62 WOLSELEY ROAD, LONDON, N8 8RP: ECO HOUSE SCHEME

NON-MATERIAL AMENDMENT APPLICATION

PLANNING STATEMENT
MARCH 2023

23. Proposed boundary fence elevation along rear gardens of Tivoli Road houses.
(Drawing number 591-120-P3 Proposed section X4-X4).

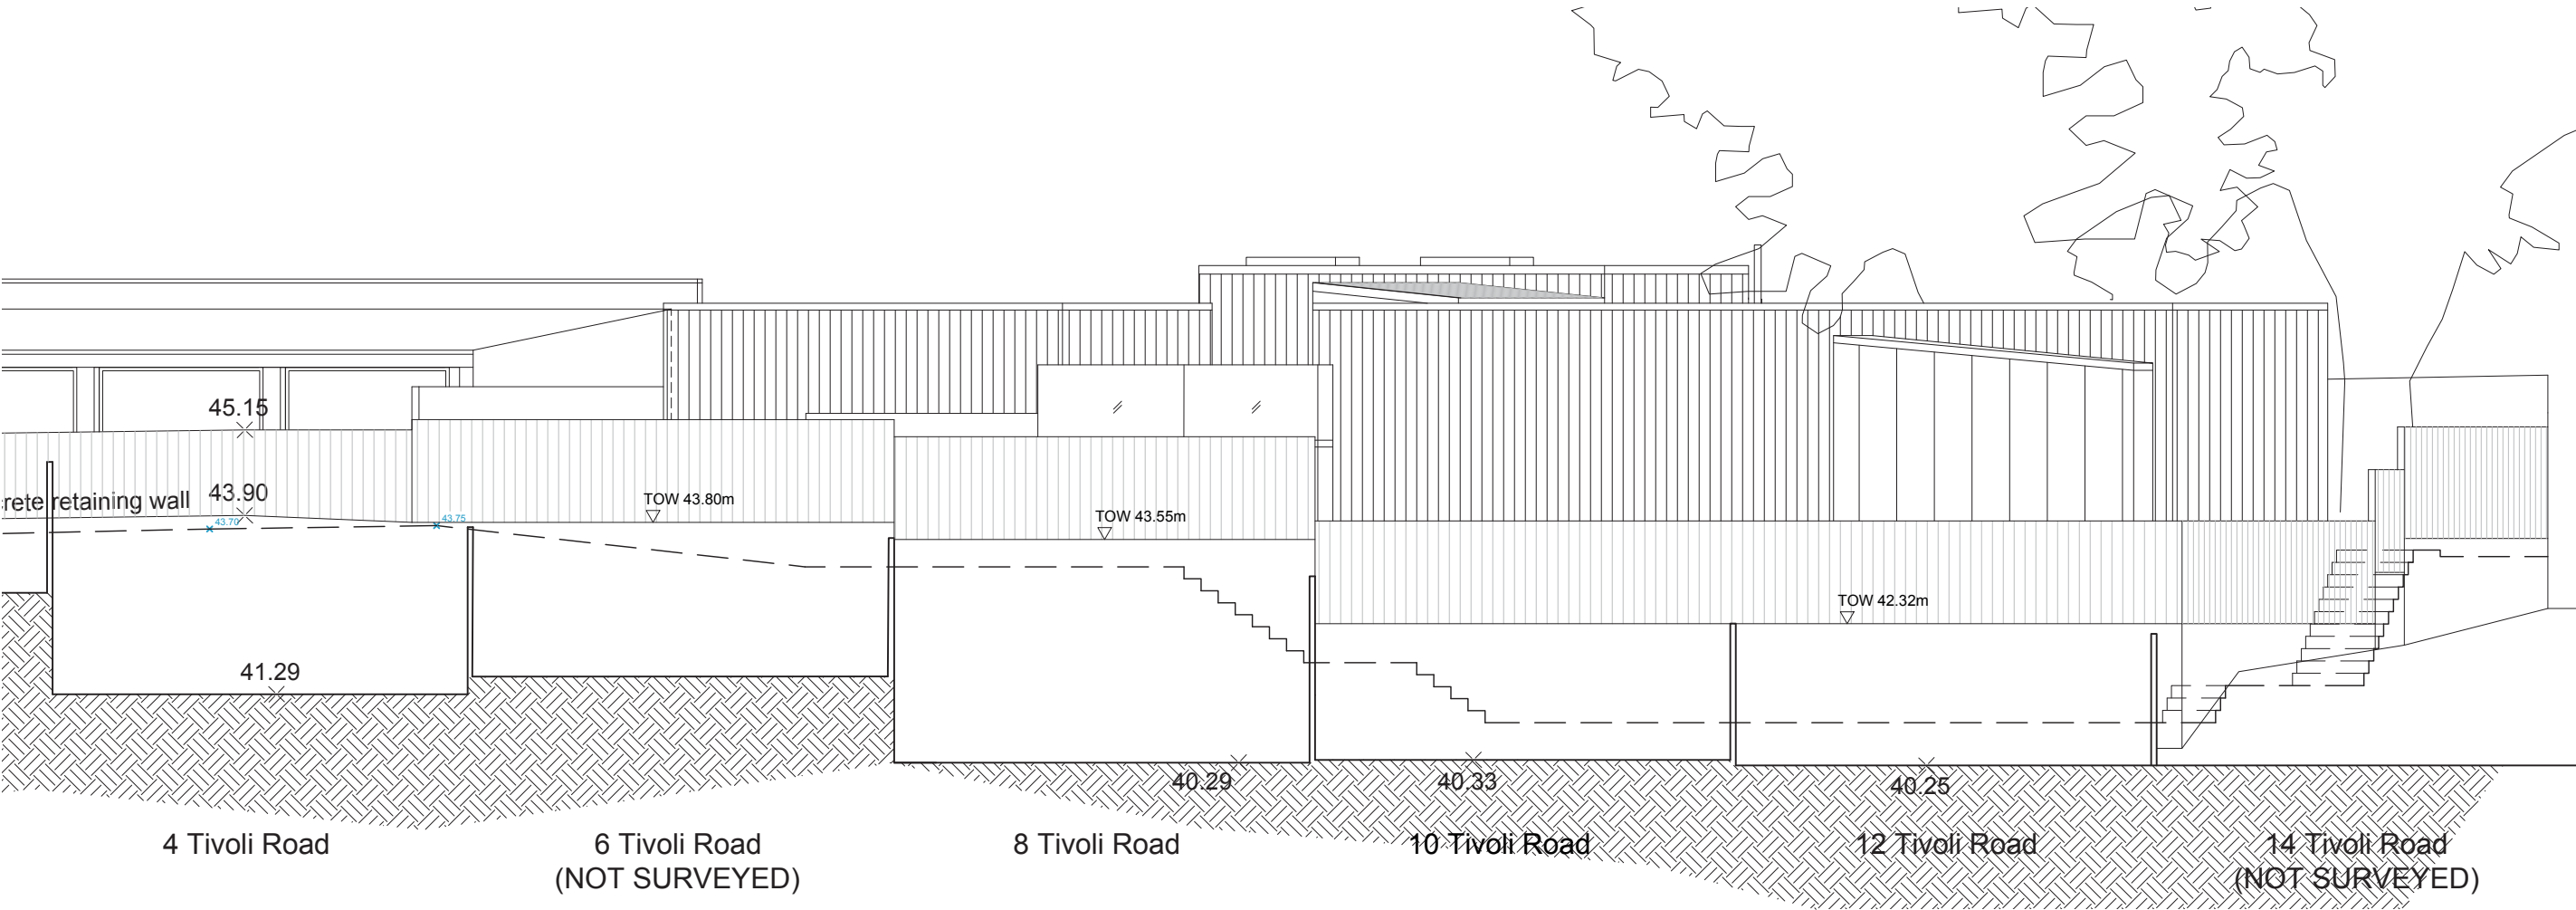
- 9.1. Fence line will be changed to a stepped configuration which was the design most appealing to the neighbouring properties on Tivoli and Glasslyn road and will now follow the future contour of the site more closely.
- 9.2. A mix of insitu concrete walls, reinforcement and retention of existing walls as well as kingpost walls will be used.
